ADDENDUM NO. 2

Alchemist Public Market

D+B Project No. C3020.00
EDA Award No. 07-01-07939
URI: 123984

From: Dreyfuss + Blackford

M1.1

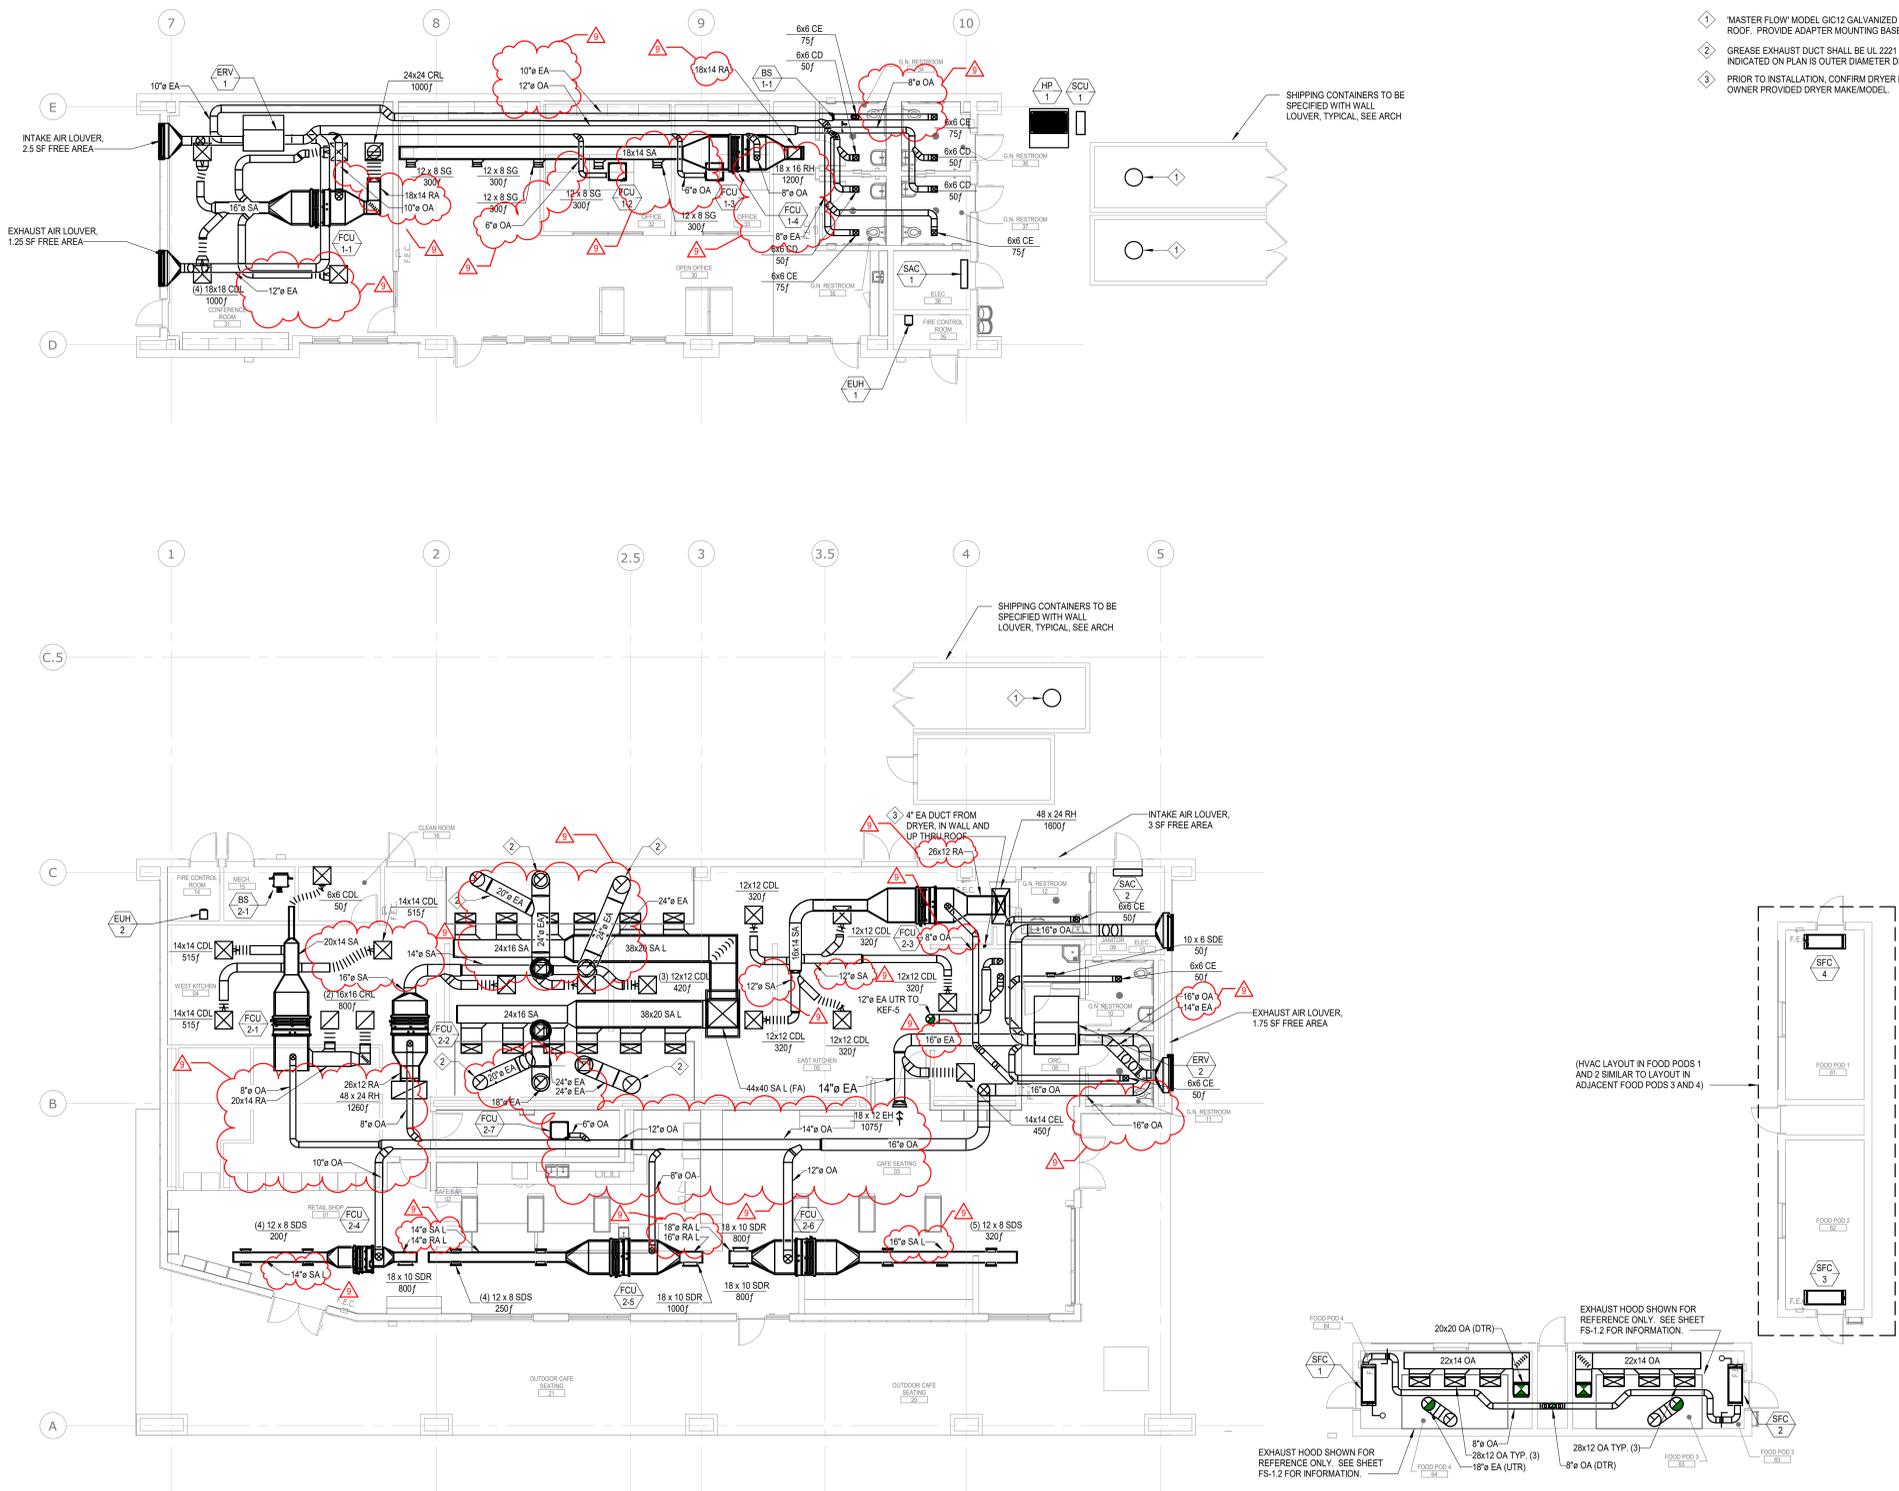
Item No.	Location of Change	Description of Change
3	M1.1	Delta 9 revisions – Updated schedule in response to bidder question #48.
4	M2.1	Delta 9 revisions – Updated HVAC plans in response to bidder question #48

46	Will the contractor be responsible for providing a separate office trailer for the inspector of record?	No
47	The “modular wall system” @ interior openings B6, B7, B8 are shown with perimeter framed doors and sidelites. The spec. calls out The basis of design to be a “Frameless glass” product. It does go on to call out a sliding aluminum door. Please clarify that these openings are to be provided as drawn with a framed door and sidelites?	Provide framed door and sidelite modular wall system at interior openings as shown on elevations on Sheet A2.41 and details on Sheet A9.20.
48	There is a size chart on sheet M1.0 however, ducts providing OSA to the FCU's are not sized and the FCU schedule does not indicate the CFM of OSA to the FCU's. Please clarify.	Outside air values added to FCU schedule. Floor plan updated to correct missing duct sizes. See updated sheets M1.1 and M2.1 included in Addendum No. 2 attachments.

ELECTRICAL LINE DIAGRAM:

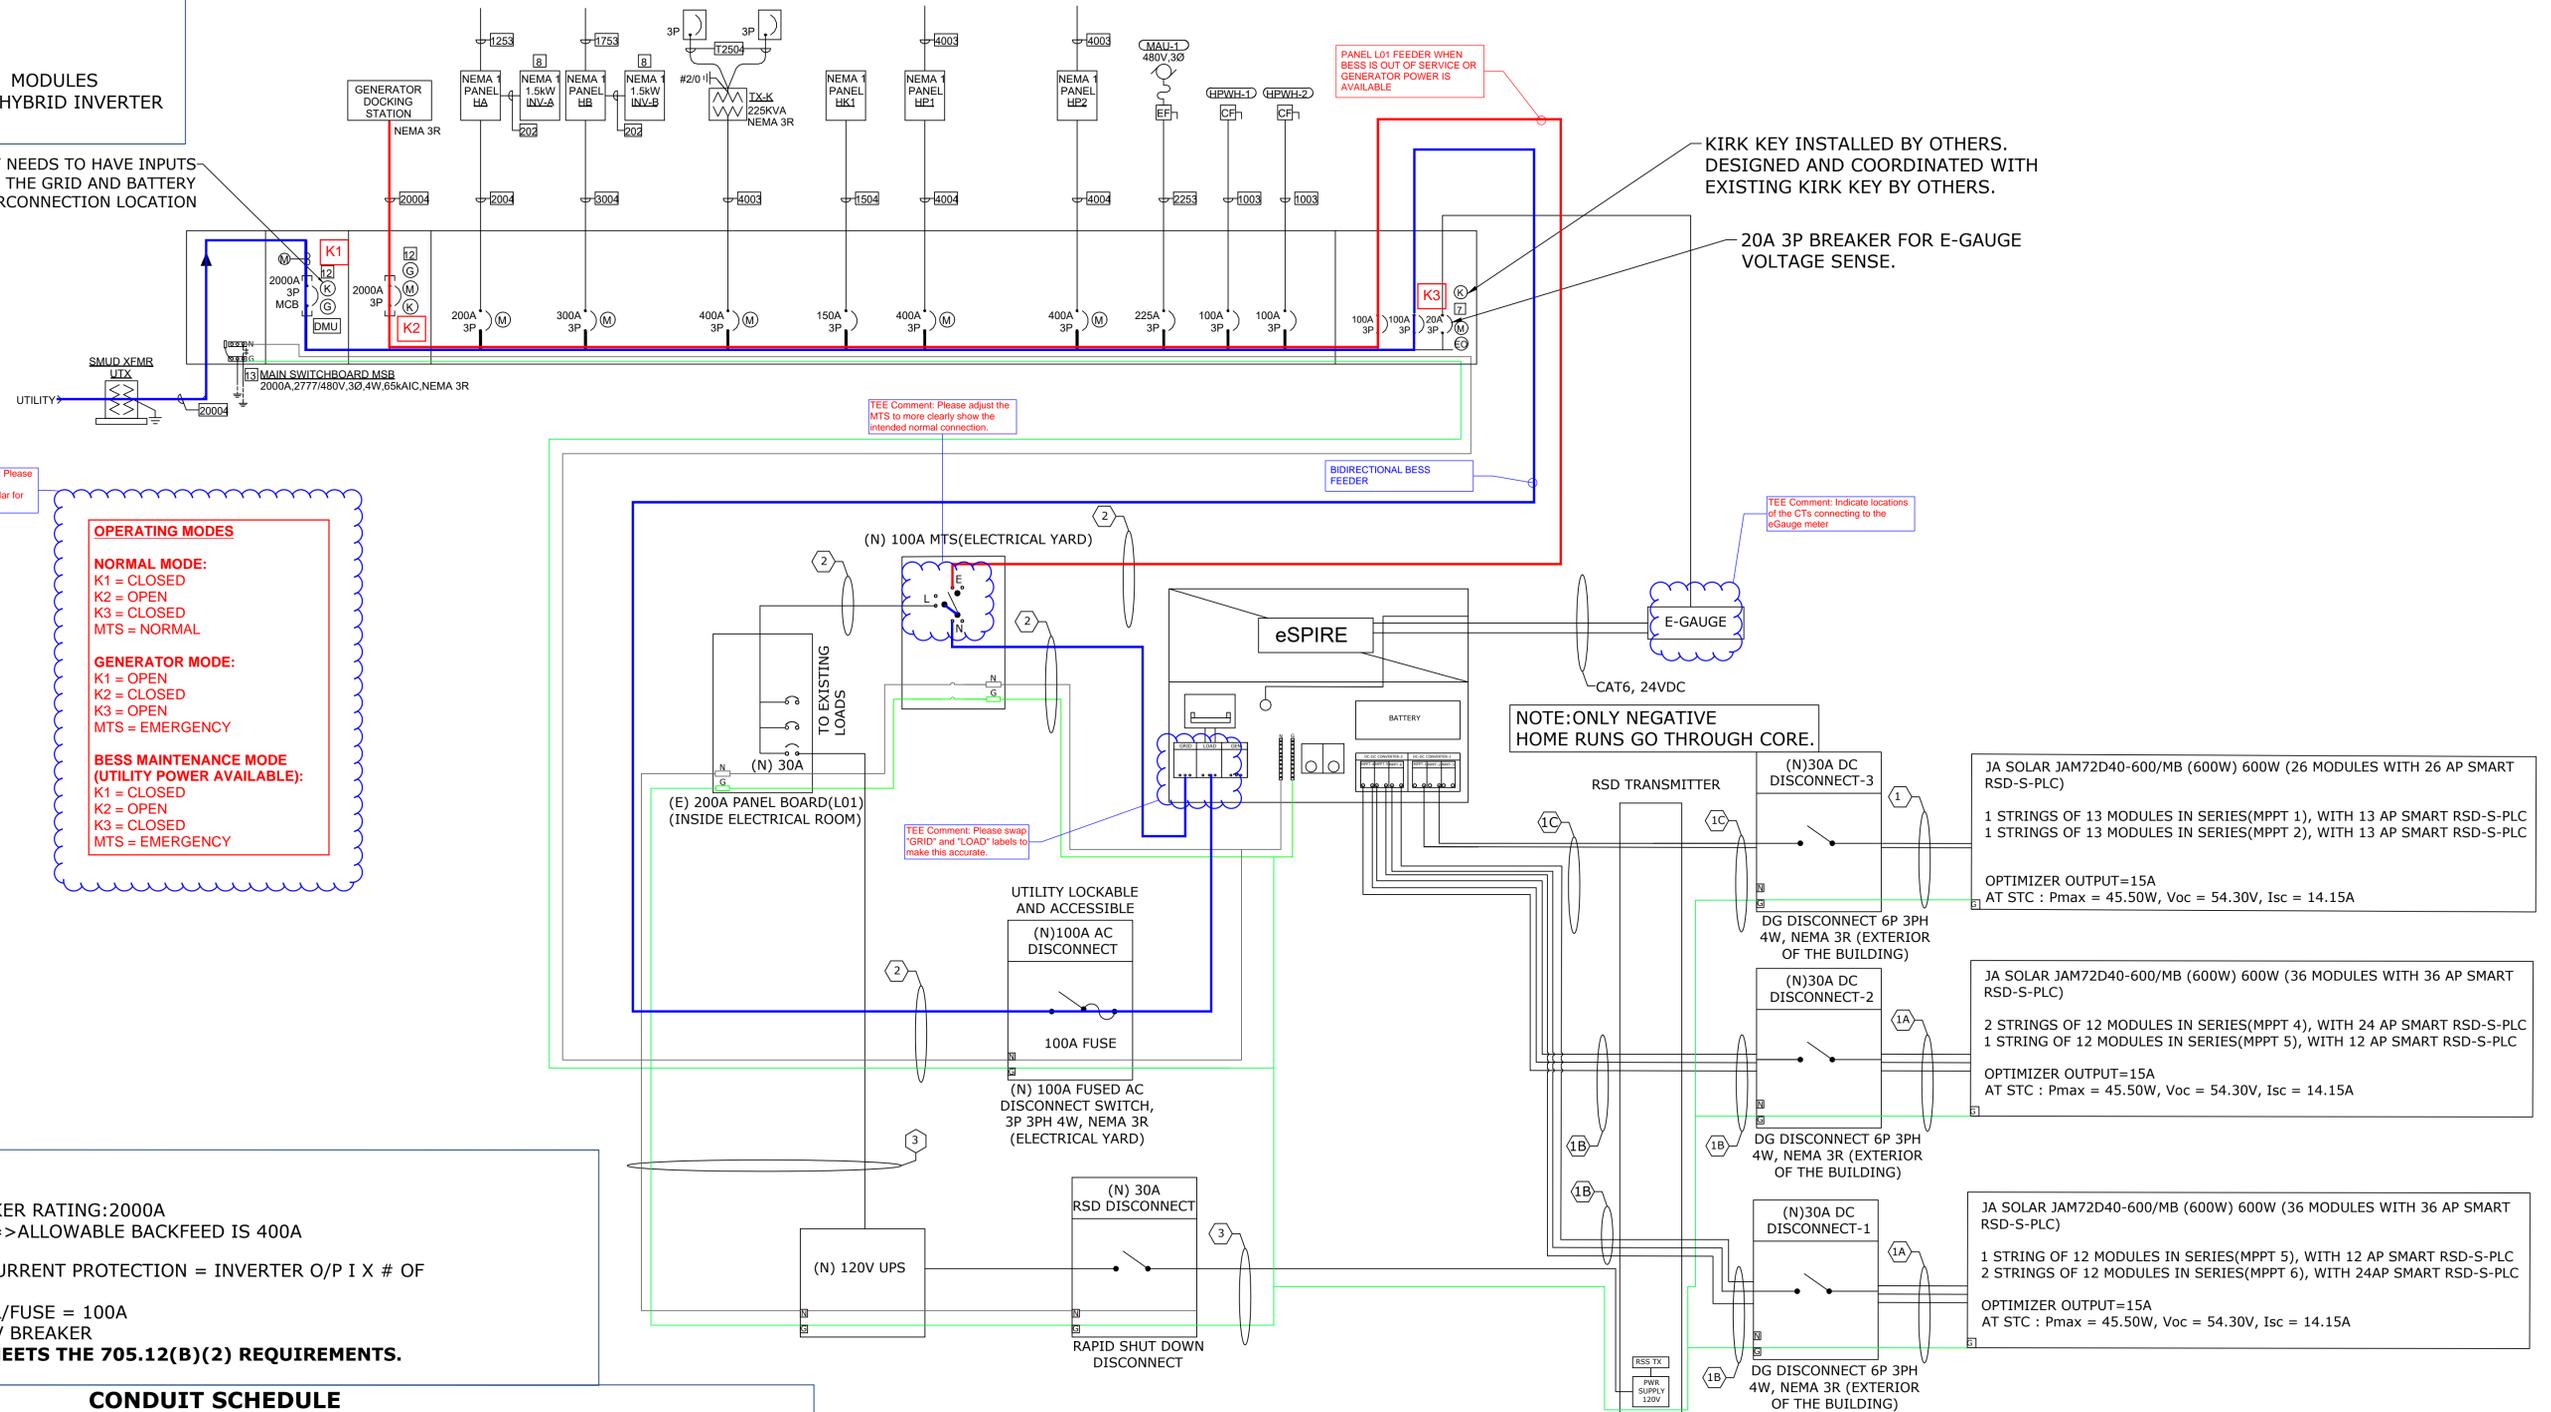
TEE Comment: Please include this or something similar for reference

TEE Comment: Please adjust the MTS to more clearly show the intended normal connection.

TEE Comment: Please swap "GRID" and "LOAD" labels to make this accurate.

TEE Comment: Indicate locations of the CTs connecting to the eGauge meter
